PLANNING APPROVAL,
PLANNED UNIT DEVELOPMENT &
SUBDIVISION STAFF REPORT

Date: May 3, 2007

<u>NAME</u>	Weinacker's Montessori School, Inc.
<u>SUBDIVISION NAME</u>	WMSHC Subdivision
<u>LOCATION</u>	227 Hillcrest Road (East side of Hillcrest Road, 625'± South of Cedar Bend Court)
<u>CITY COUNCIL DISTRICT</u>	District 5
<u>PRESENT ZONING</u>	R-1, Single-Family Residence District
<u>AREA OF PROPERTY</u>	1 lot / 1.6 acres ±
<u>CONTEMPLATED USE</u>	Planning Approval to allow a school in an R-1, Single-Family Residential District, Planned Unit Development approval to allow multiple buildings on a single building site, and Subdivision approval to create one legal lot.
<u>TIME SCHEDULE FOR DEVELOPMENT</u>	Immediate

SITE PLAN

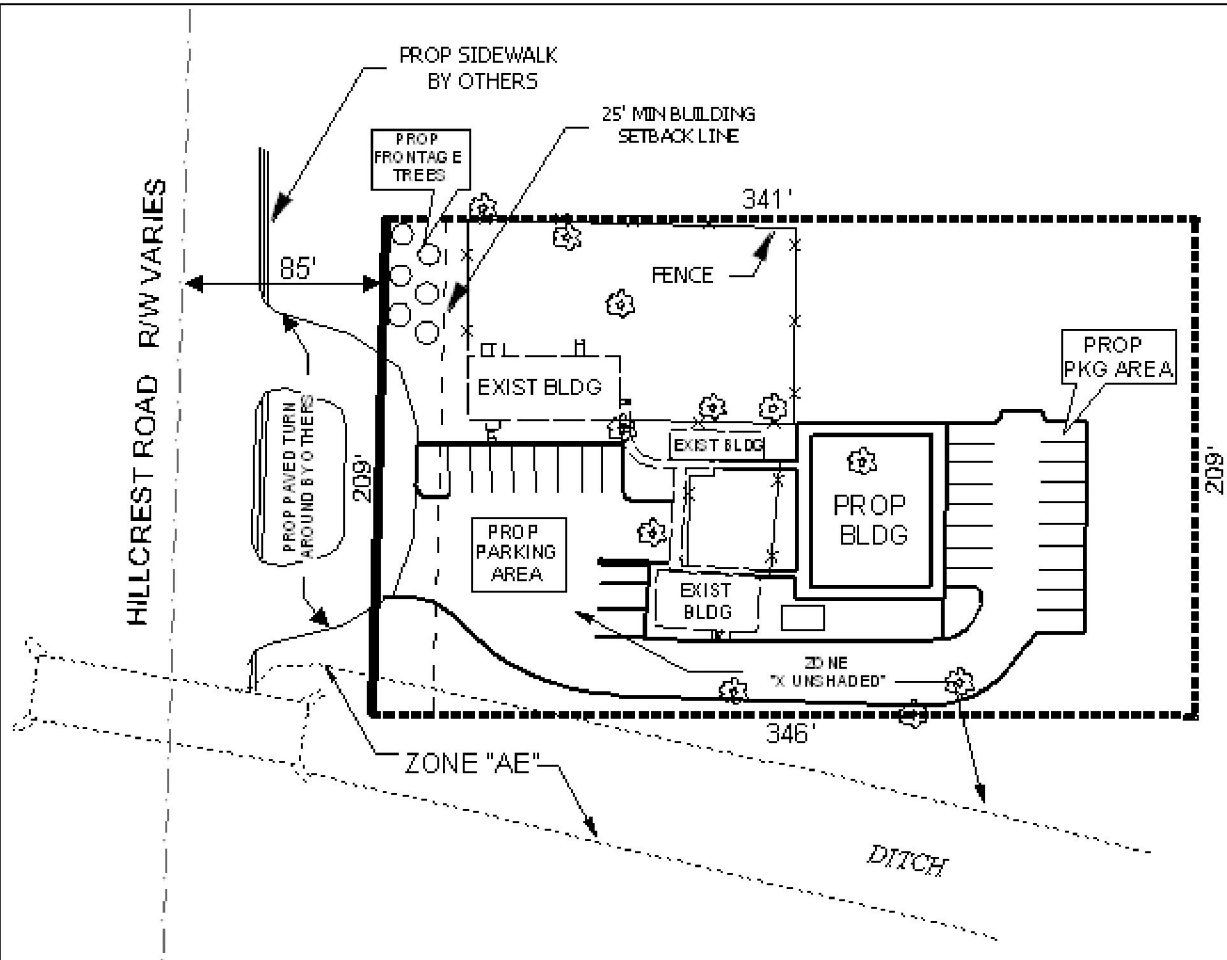
Regarding on-site circulation, gravel cannot be used as a maneuvering or parking surface, thus the site plan should be revised to clearly show asphalt where the "existing gravel drive" is labeled. The "existing gravel drive" area also appears to have excessive width, thus a redesign of this area is recommend, perhaps providing a traffic circle type facility to allow parents to easily circle to drop-off and pick-up children, and allowing school staff access to the parking area in the rear.

The site plans should be revised to depict a fence or protection buffer strip along the North, East and South perimeters of the site, in accordance with Section 64-4.D.1. of the Zoning Ordinance.

Due to the size of the proposed parking area, a note should be placed on the site plans stating that the parking area will be illuminated in accordance with the requirements of Section 64-6.A.3.c. of the Zoning Ordinance, if the parking area is used at night.

- 1) Revision of the site plan to depict a dumpster or waste storage facilities, in compliance with Section 64-4.D.9. of the Zoning Ordinance;*
- 2) Revision of the site plan to depict any required storm water detention facilities;*

- 3) Compliance with Engineering comments (Show flood way. No detention in AE flood plain. No fill in AE flood plain without flood study. Must comply with all storm water and flood control ordinances. Any work performed in the right of way will require a right of way permit.)*

- 4) Revision of the site plan to clearly depict paving of all vehicular circulation and parking areas, and revision of the front "existing gravel drive" area to reduce the excessive driveway width or provide a circular pick-up and drop-off facility with central landscaped area;*

The applications were heldover from the July 19th meeting at the applicant's request. The applicant submitted revised site plans and a plat that depict an increase in paved parking from 18 to 29 total spaces. The site plan does not indicate a storm water detention facility, which may be required due to the amount of new paved area.

- 1) Revision of the site plan to depict a dumpster or waste storage facilities, in compliance with Section 64-4.D.9. of the Zoning Ordinance;*
- 2) Revision of the site plan to depict any required storm water detention facilities;*

- 3) Compliance with revised Engineering comments (Show minimum finished floor elevation. Label flood zone/floodway. Check the need for 100-year detention with 10-year release with the City Engineer. It is the responsibility of the applicant to look up the site in the City of Mobile (COM) GIS system and verify if NWI wetlands are depicted on the site. If the COM GIS shows wetlands on the site, it is the responsibility of the applicant to confirm or deny the existence of wetlands on-site. If wetlands are present, they should be depicted on plans and/or plat, and no work/disturbance can be performed without a permit from the Corps of Engineers. Must comply with all storm water and flood control ordinances. Any work performed in the right of way will require a right of way permit.)*

- 6) *Revision of the site plan to clearly depict a fence or protection buffer strip along the North, East and South perimeters of the site, in accordance with Section 64-4.D.1. of the Zoning Ordinance;*

- 8) *Placement of a note on the site plan stating that the site is limited to the existing curb-cut onto Hillcrest Road, and denied access to the unopened public right-of-way on the Eastern boundary of the lot, with the size, design and location of the curb-cut to be approved by Traffic Engineering and in compliance with AASHTO standards;*
